Subject: Parramatta Site Establishment Heavy Vehicle Local Roads Request for Sydney Metro West
(Condition D86 of SSI-10038)

HEAVY VEHICLE LOCAL ROAD REPORT SITE ESTABLISHMENT

Sydney Metro West – Western Tunnelling Package

REVIEW COMMENTS SHEET

Figure 7-2: Swept path analysis locations for site establishment phase of works

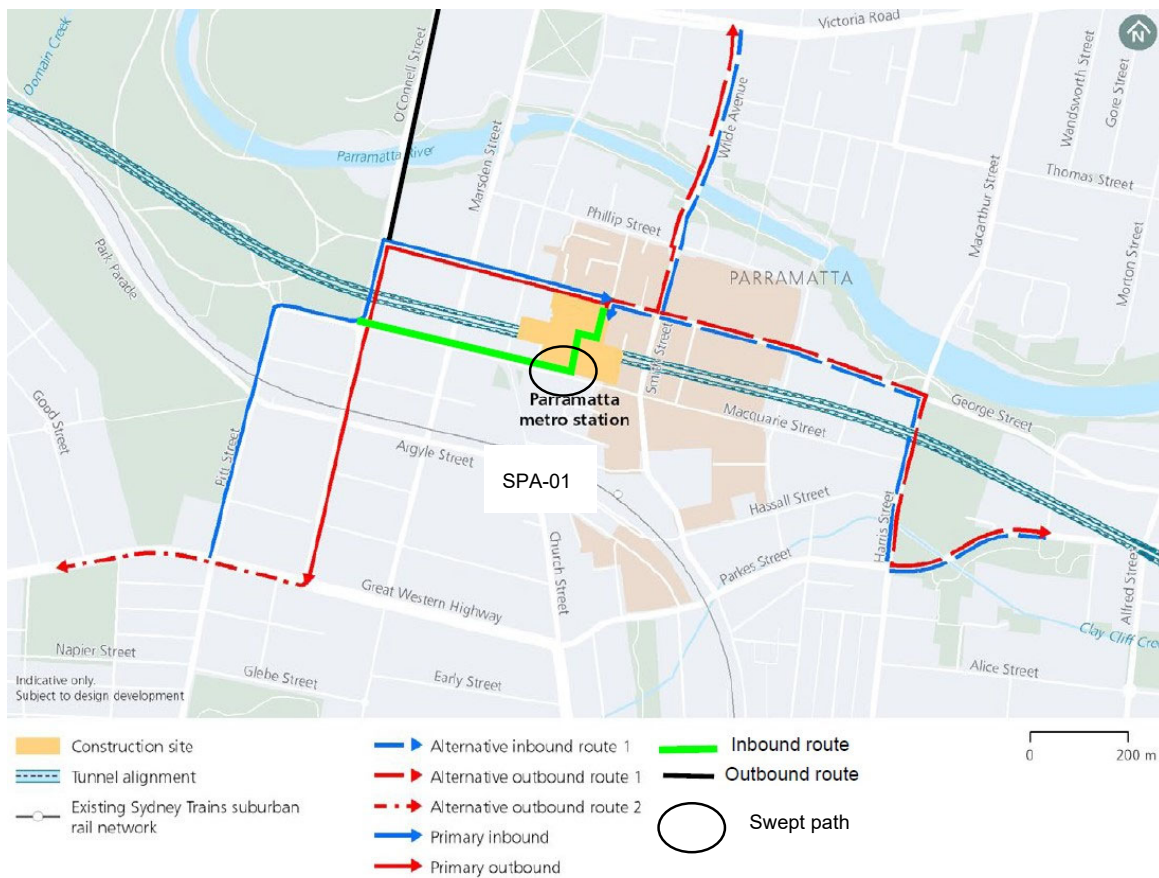
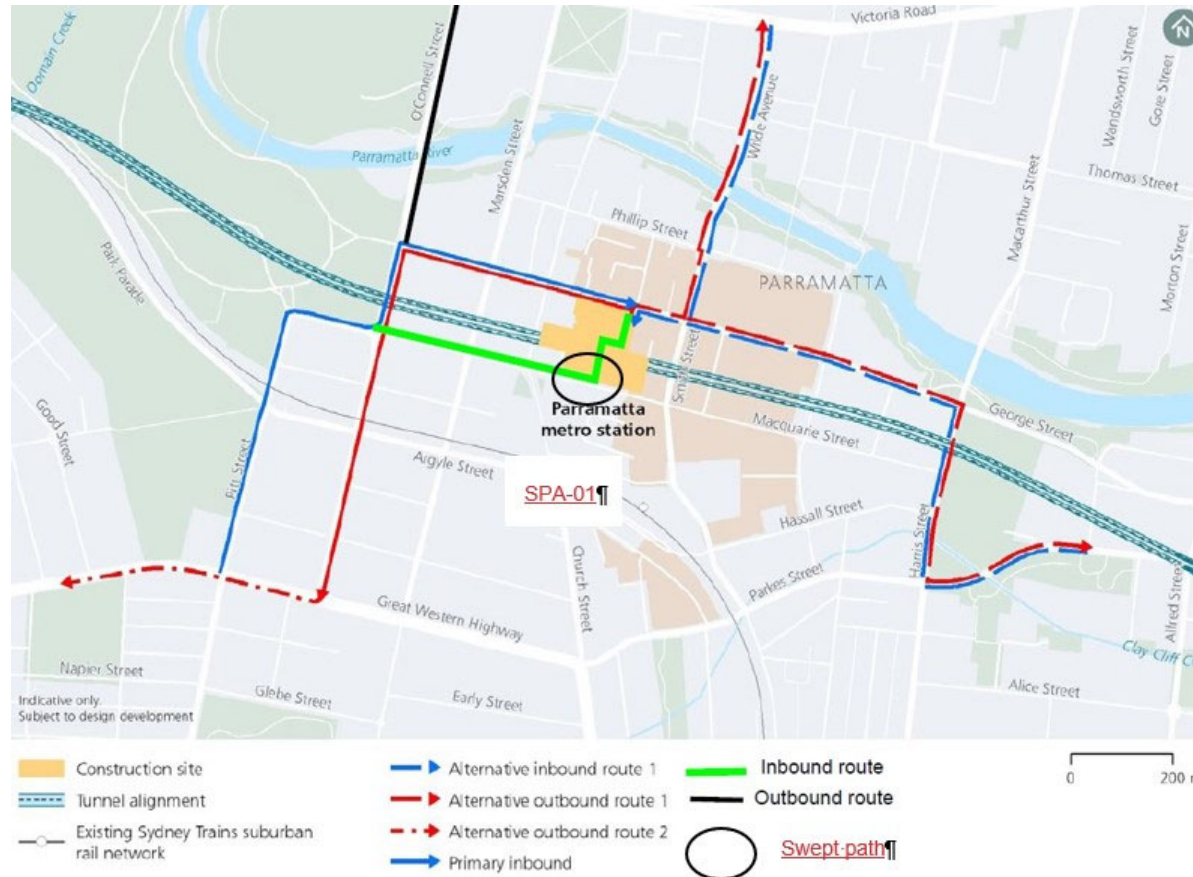
08.01.01	27/05/2022	TFN	LWILBY				Response noted, comment closed.	Observation	Y
												Observation	Y
				09	9/05/2022	SMD	BGORDON	SMWSTWTP-GLO-PTA-TF-RPT-000001	Flgure 7.2	MCoA D87	Figure 7-2 and 8-1 show the same inbound route for heavy vehicles. The outbound route/s for heavy vehicles, are two lines at the bottom of the first paragraph in Section 7.3. To improve clarity consider one map shewing all routes, maybe even an overlay of inbound and outbound routes over the EIS route map, allowing a clear comparison.	Observation	N
								SMWSTWTP-GLO-PTA-TF-RPT-000001	Flgure 7.2	MCoA D87		Observation	N

09.01	24/05/2022	GLO	DKELLY	SMWSTWTP-GLO-PTA-TF-RPT-000001	Flgure 7.2	MCoA D87	No change to document as it is quite clear what swept paths are being undertaken	Observation	N
							DKELLY	SMWSTWTP-GLO-PTA-TF-RPT-000001	Flgure 7.2	MCoA D87	Document amended	Observation	N
				11	16/05/2022	SMD	SCLARKE	SMWSTWTP-GLO-PTA-TF-RPT-000001	Definitions/ Abbreviations	N/A	Update DPIE to DPE	Observation	Y
								SMWSTWTP-GLO-PTA-TF-RPT-000001	Definitions/ Abbreviations	N/A		Observation	Y

A : SWEPT PATH ANALYSIS

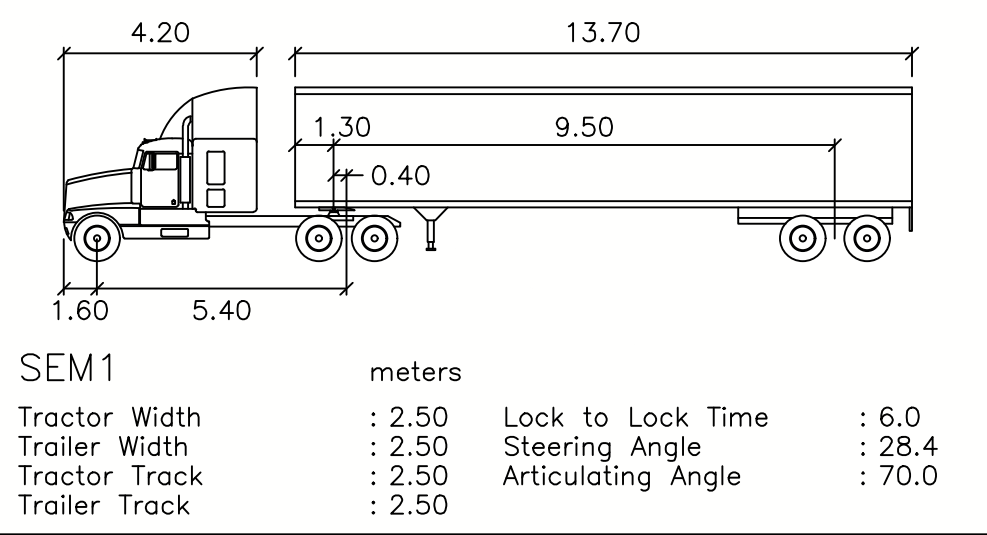
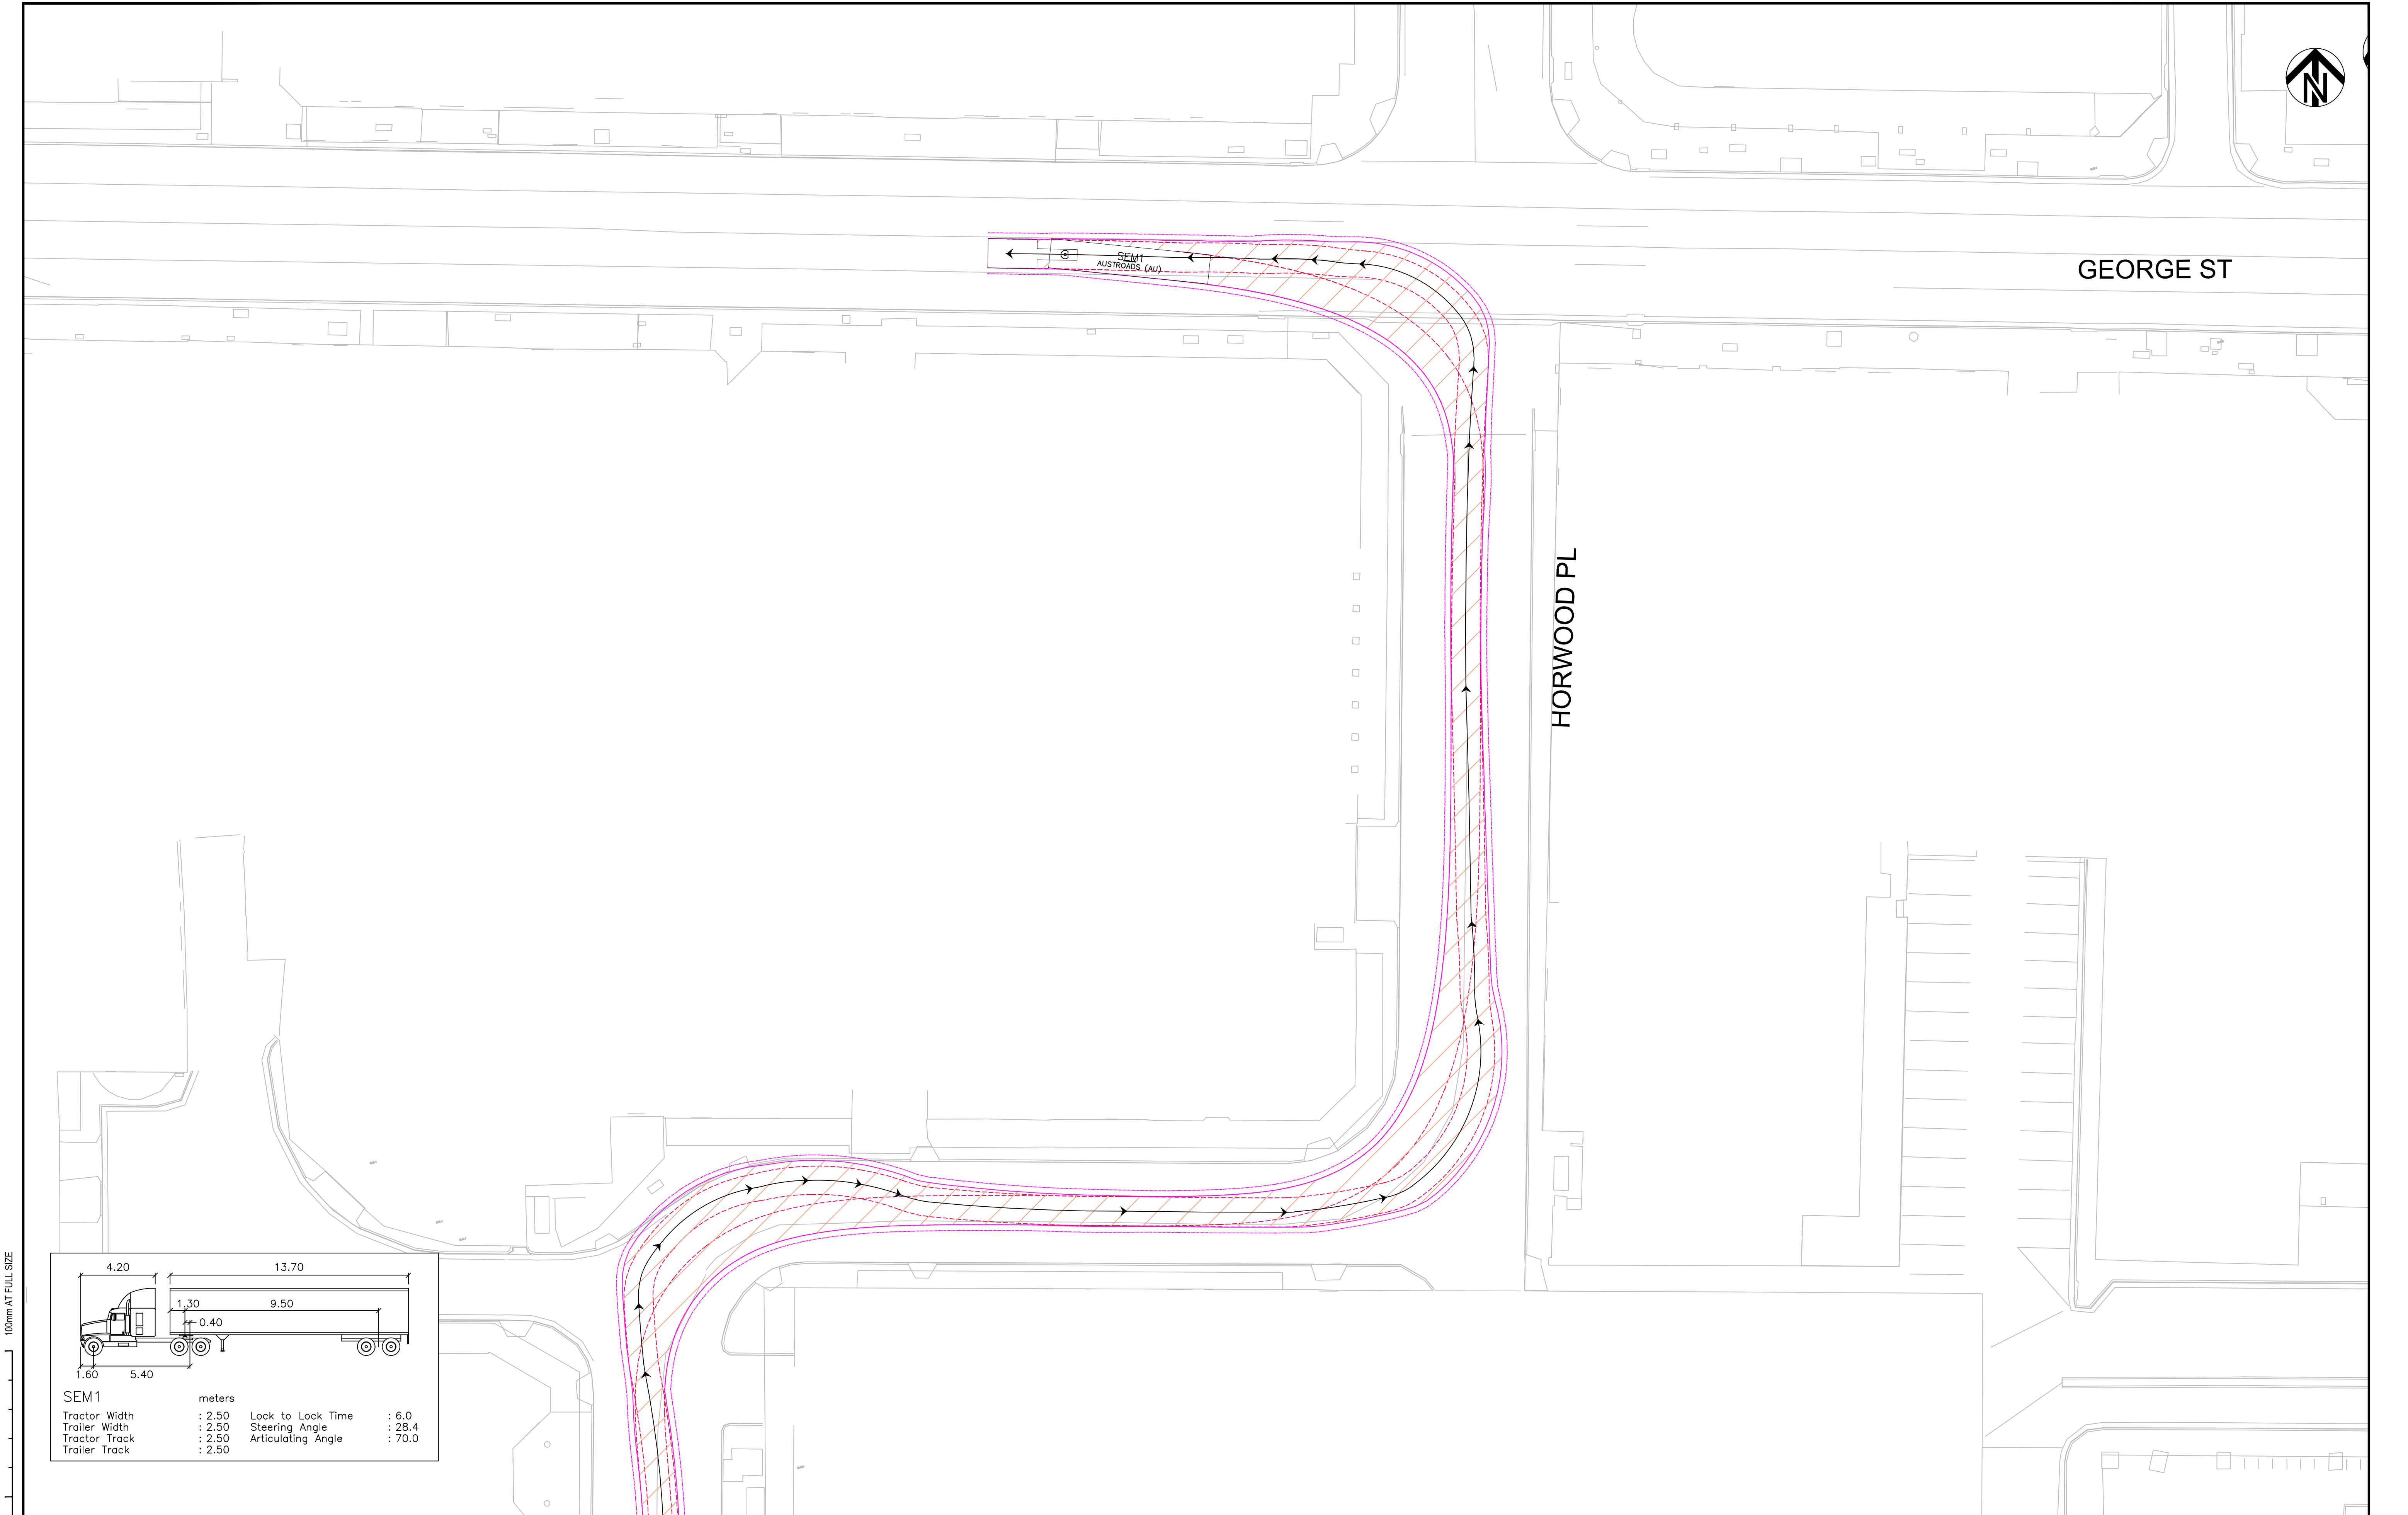
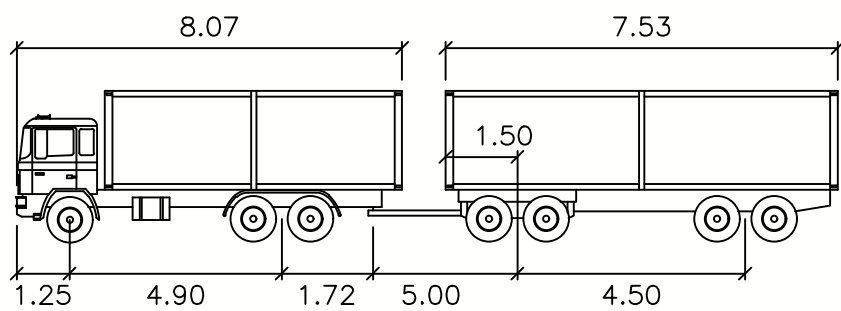
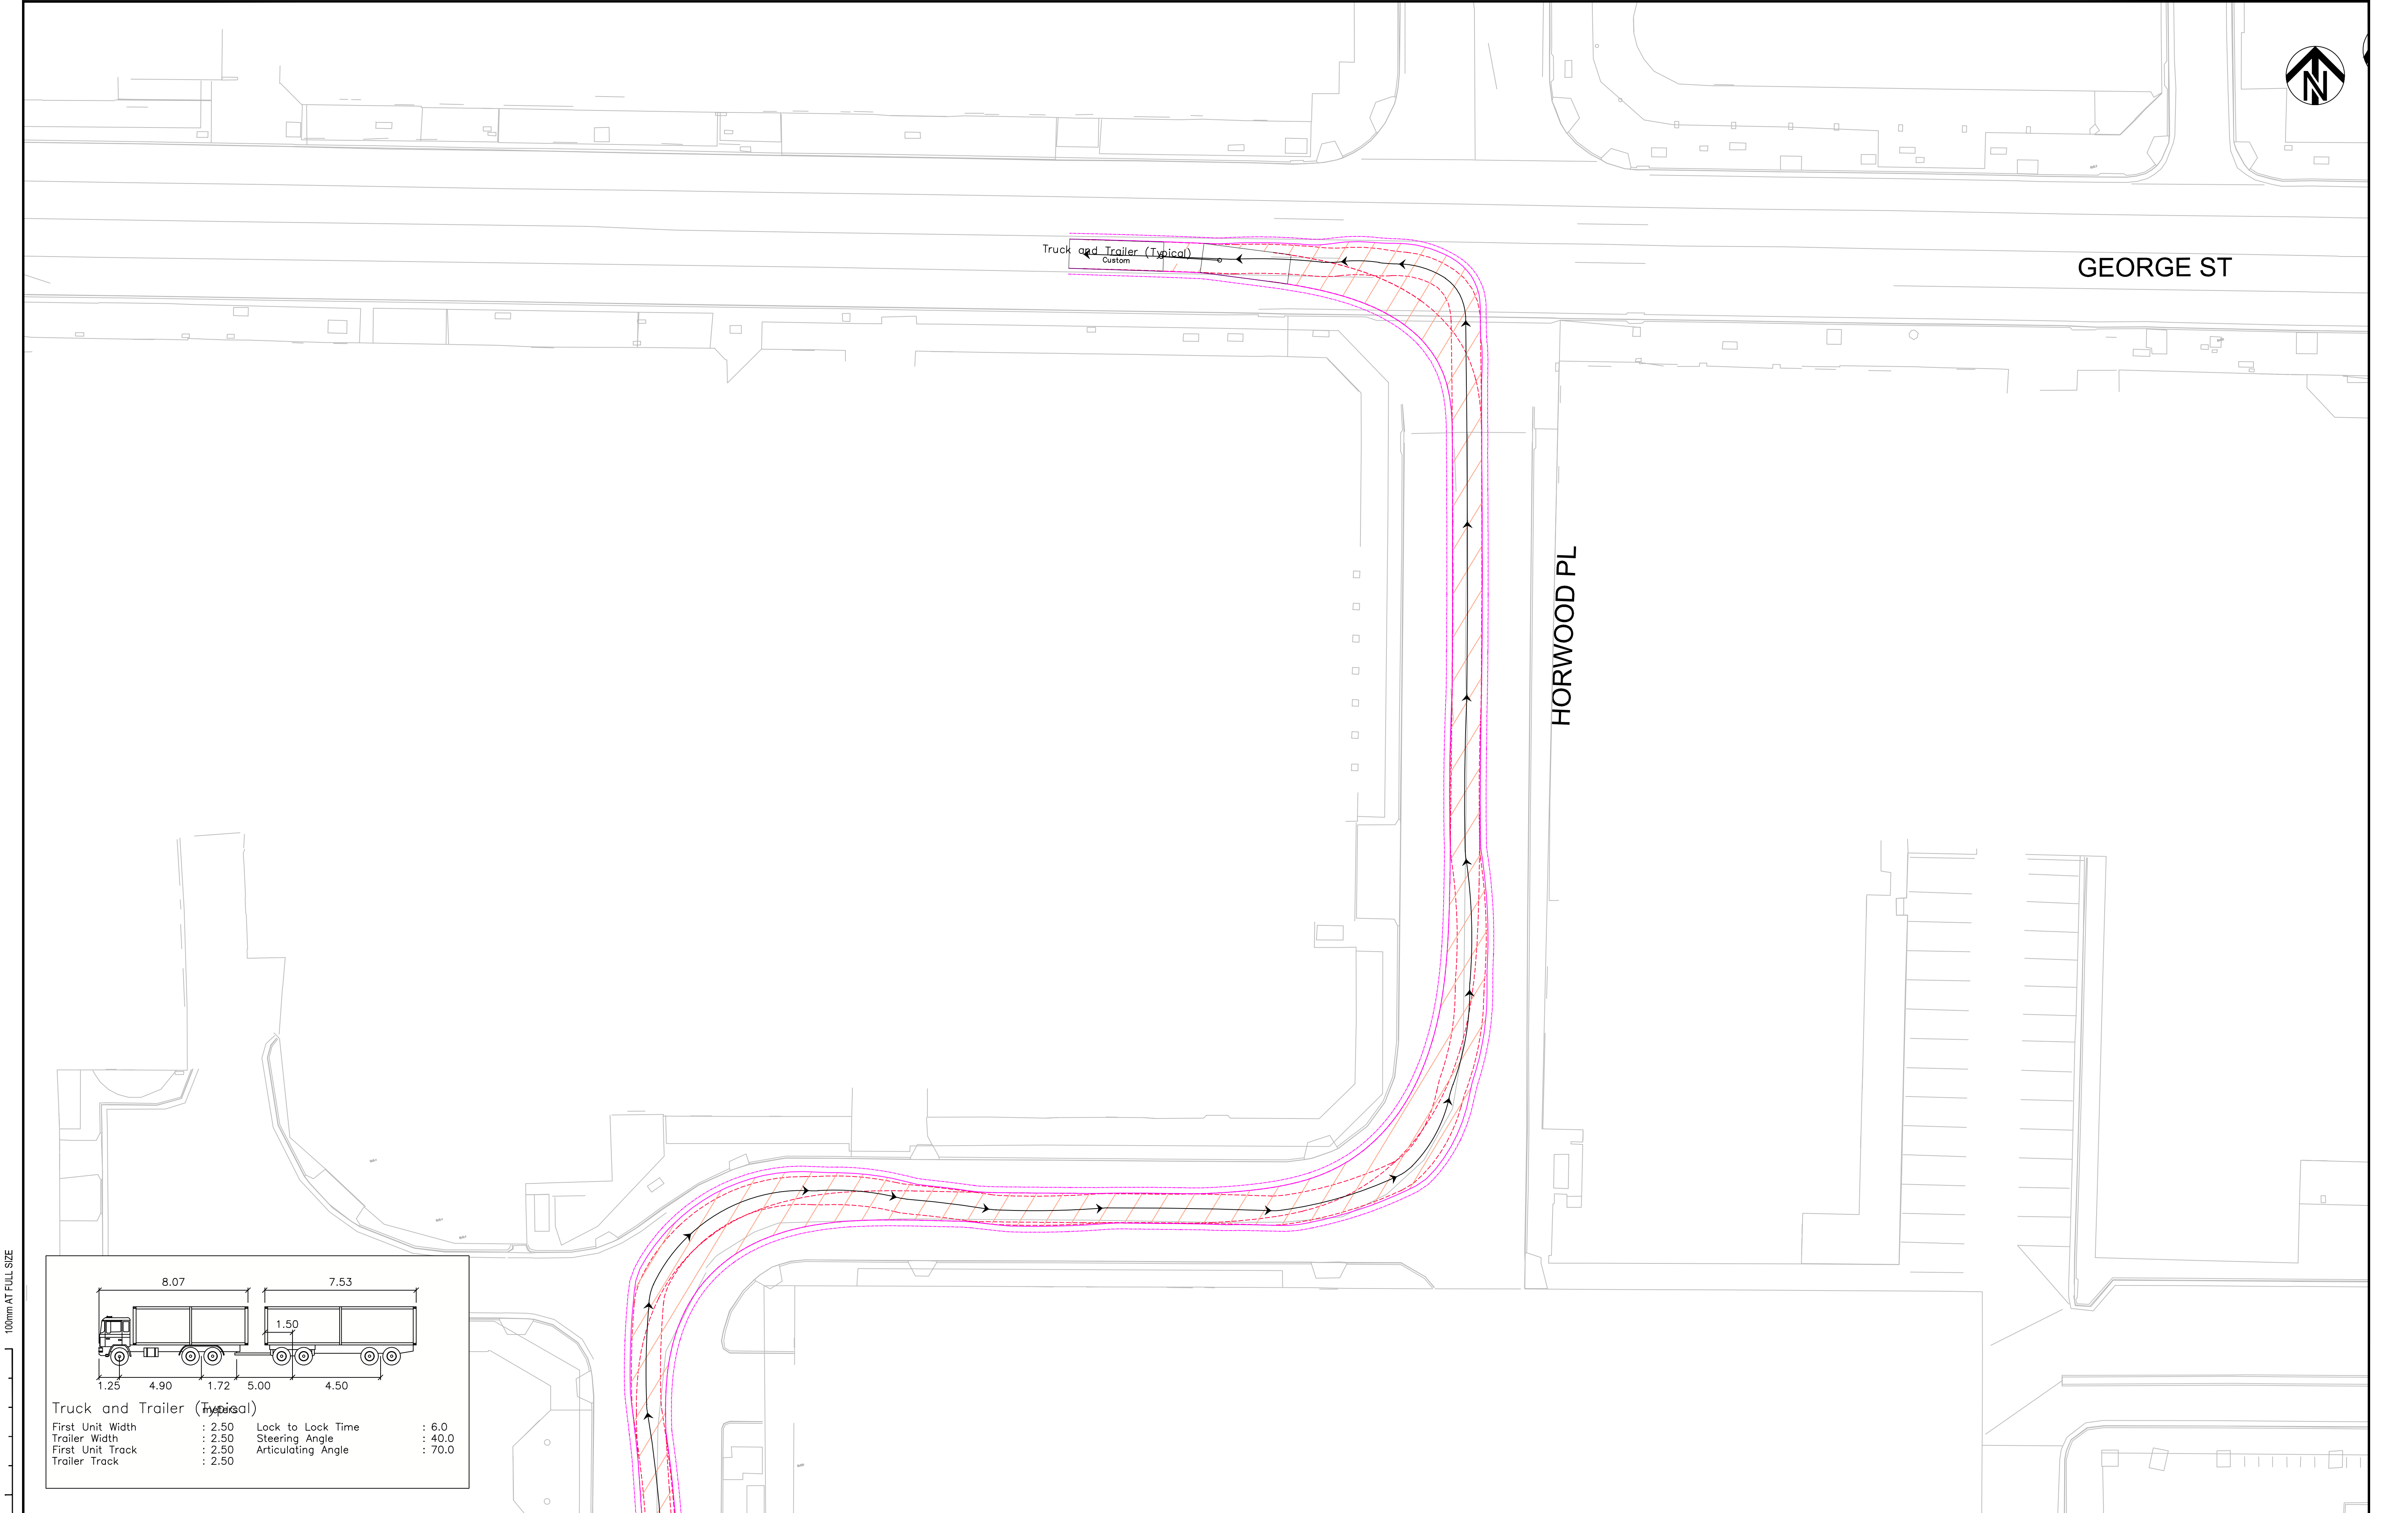
DOCUMENT NO.	TITLE	VER	STATUS	NO.	DATE	COMPANY	RAISED BY	REVIEW DOC. NO.*	DOCUMENT REF*	DEED REF*	COMMENTS / RESPONSE	COMMENT CATEGORY*	CLOSED OUT
				08	9/05/2022	TFN	LWILBY	SMWSTWTP-GLO-PTA-TF-RPT-000001	A: Swept Path Analysis	NA	The swept path for both vehicles from the left turn movement from Horwood into George Street indicates that they will either overhang the centre line or leave very little margin for error. This increases the risk of head on collision with vehicles travelling along George Street. Please consider and demonstrate what else can be reasonably done to prevent collisions in this location.	Observation	Y
								SMWSTWTP-GLO-PTA-TF-RPT-000001	A: Swept Path Analysis	NA		Observation	Y
